Re: **Tronox LLC (TRX) Facility
Nevada Environmental Response Trust (Trust) Property
NDEP Facility ID #H-000539**
Nevada Division of Environmental Protection (NDEP) Response to: *Baseline Health Risk
Assessment Work Plan for Ou-3*

Dated: February 28, 2022

Attachment A

Figure
4-1

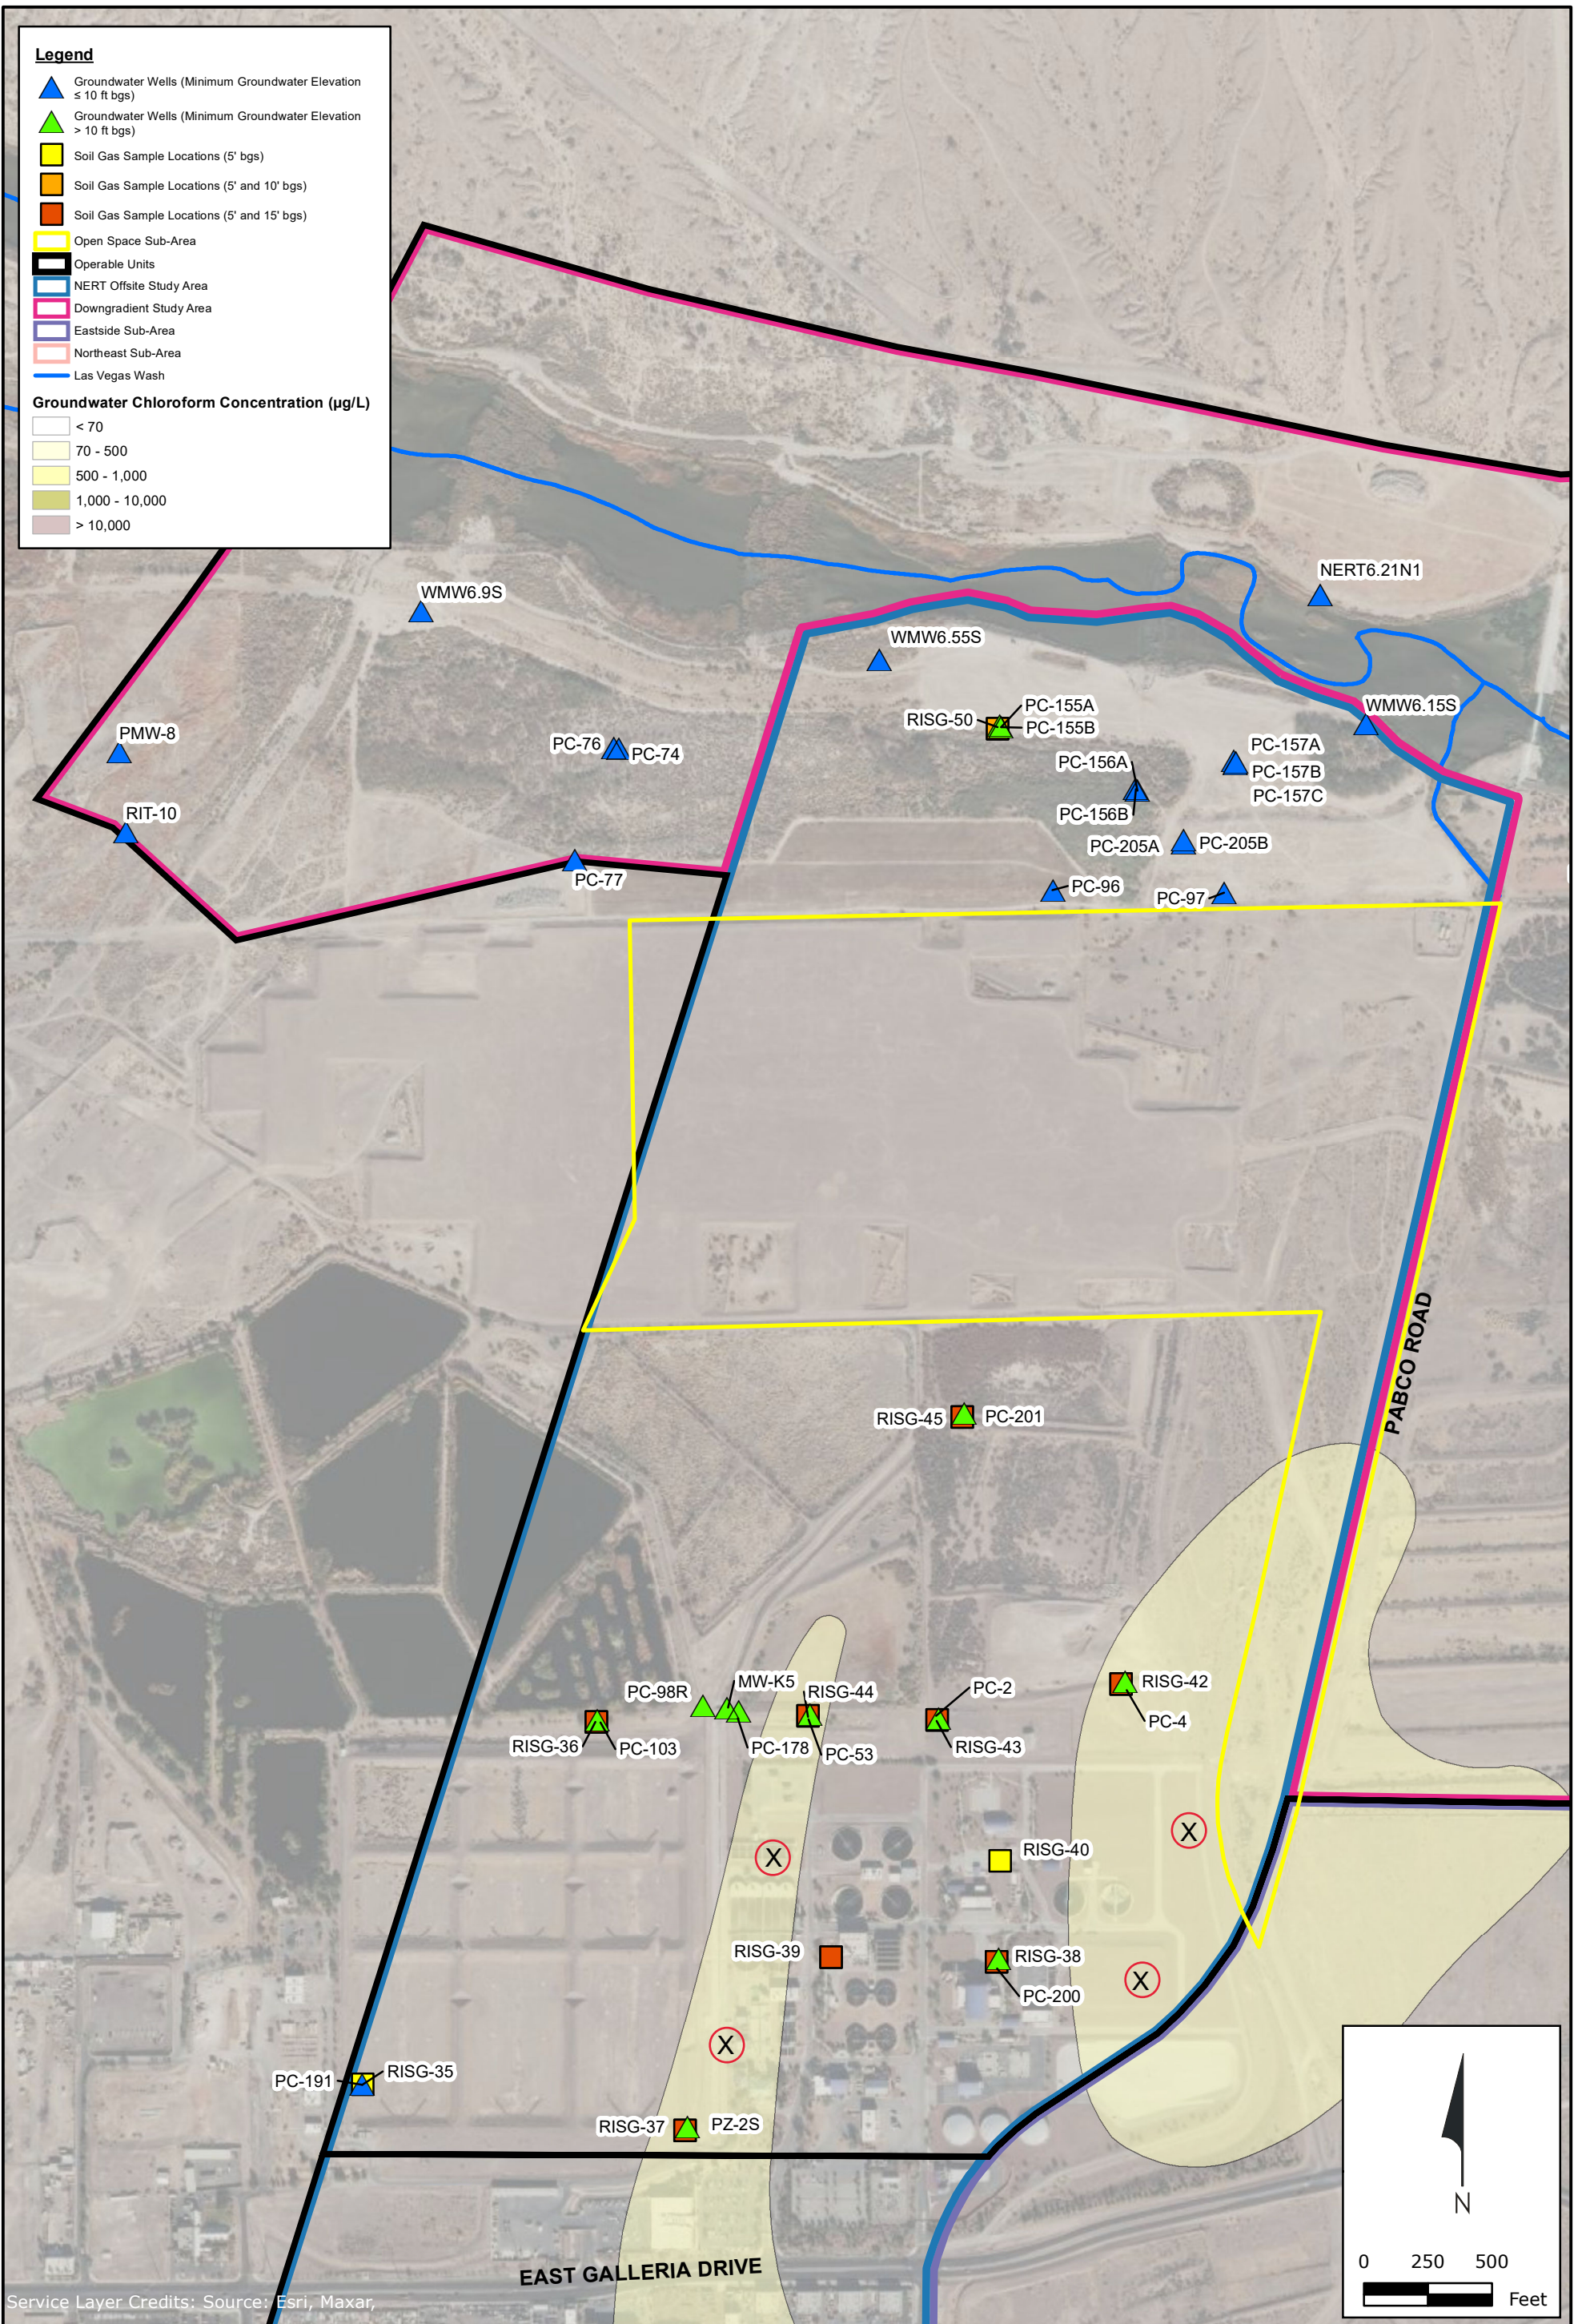
The Department's primary concern is that the data may not be adequate to assess risk and may not represent worst case or Reasonable Maximum Exposure (RME) conditions. For example, there are only 16 soil gas borings for the area west of Pabco Road and these appear to be predominantly located outside the chloroform plume. Assuming this area on Figure 4-1 with the chloroform plume west of Pabco Road is within the area impacted by the NERT core plumes, it is suggested to add at least two more soil gas sampling locations within the interior of each of the two plume areas shown. Figure 4-1 from the Deliverable with example points in red circles is provided as an attachment.

Specific Comment #4 Section 4.1, Section 5.1.1, and Figure 4-1

These sections state that there are 16 soil gas sampling locations and a total of 13 soil gas probe locations and refers to Figure 4-1. Please explain the difference between the 16 sampling locations and the 13 soil gas probe locations. Based upon the database, there are soil gas data available for 16 locations; however, Figure 4-1 appears to only depict 11 due to some locations having multiple depths. Please clarify the apparent discrepancies by making it easier to identify each sample and depth location on the map. Find a way to show the depth information where appropriate, whether by labeling or making each depth square a different size in addition to the different colors, paying attention to rendering order. In addition, please provide information regarding the quantity of samples and choice of sampling locations, as they do not appear to be sufficient to assess risk and they do not appear to represent worst case conditions.
